#tnl2018-0021e # 1 / 2

Change of the Amplifiers for the Blade Breakage Detector and Non-contact Setup Sensor of a Dicing Saw

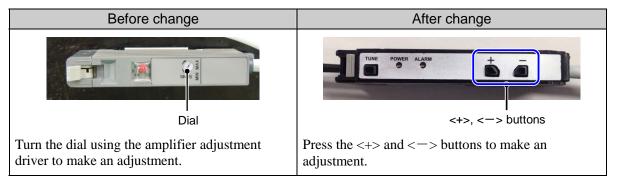
The sensitivity adjustment amplifiers for the blade breakage detectors and non-contact setup sensors of our dicing saws have gone out of production (with some exceptions). We have started to ship the machines equipped with new-type amplifiers.

There are differences in the procedure for adjusting the sensitivity between with the amplifiers before the change and with those after the change.

If the appearance of the amplifier installed in your machine is different from the one described in the Maintenance Manual included with the machine, replace the procedure for adjusting the sensitivity as follows:

The adjustment procedure is described in the following section:

Section 1 of Chapter E in Maintenance Manual:

- "Adjusting the Non-Contact Setup Amplifier", and
- "Adjusting the Amplifier of Blade Breakage Detector"

• For any of the machines, there is no change in the amplifier installation position.
